Access Compliance Report

Public Rights-of-Way

Intersection ID: 43648	Main Street: CAMDEN_MEADOW_DR	Cross Street: SWANN_BRANCH_DR	Location: SW
ADA ID: E3DCBCD7D2C9	Ramp Type: PerpDiag	Initial Pass/Fail: Fail	Overall Compliance: No
Severity Score: 10			
Codes/Mitigation Info/Possible Solution		Field Measurements/Component Compliance

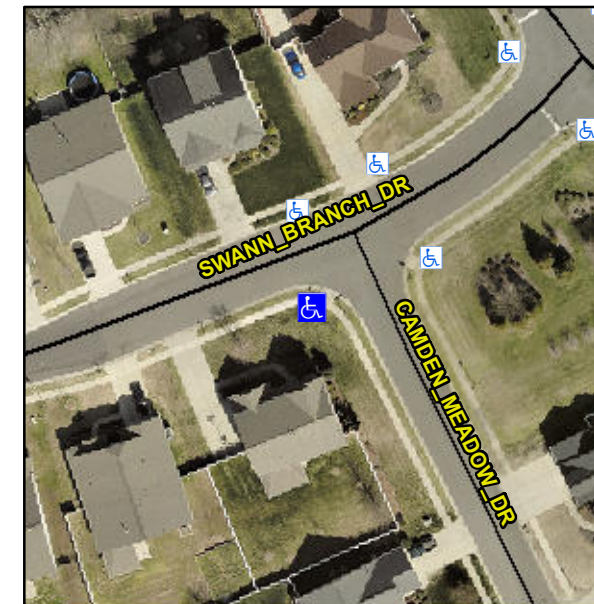
Not Found, R304.5.1, R304.5.3

Compliance	Description	Data	Compliance	Description	Data
N/A	Ramp Length (in)	47.5	Yes	Ramp Slope (%)	6.9
No	Ramp Width (in)	46.0	No	Ramp XSlope (%)	2.3
N/A	Flare Type LT	N/A	N/A	Flare Type RT	N/A
N/A	Flare Slope LT (%)	N/A	N/A	Flare Slope RT (%)	N/A
N/A	Flare Traversable LT?	N/A	N/A	Flare Traversable RT?	N/A
N/A	Landing Length (in)	N/A	N/A	DWS Provided?	N/A
N/A	Landing Width (in)	N/A	N/A	DWS Contrast?	N/A
N/A	Landing Slope (%)	N/A	N/A	DWS Length (in)	N/A
N/A	Landing X Slope (%)	N/A	N/A	DWS Full Width?	N/A
N/A	Landing Curb? (Y/N)	N/A	N/A	DWS Offset (in)	N/A
N/A	Shared Landing?	N/A			
N/A	Gutter Ponding?	N/A	N/A	Gutter Slope (%)	N/A
N/A	Gutter Lip Ht (in)	N/A	N/A	Gutter X Slope (%)	N/A
N/A	Painted X Walk1?	No	N/A	Painted X Walk2?	No
	X Walk 1 Direction	To E		X Walk 2 Direction	To N
N/A	X Walk 1 Width (in)	N/A	N/A	X Walk 2 Width (in)	N/A
	X Walk 1 Slope (%)	2.6		X Walk 2 Slope (%)	3.9
	X Walk 1 X Slope (%)	1.3		X Walk 2 X Slope (%)	1.8

Remove & Replace Curb Ramp With Two New Directional Ramps or Equivalent.
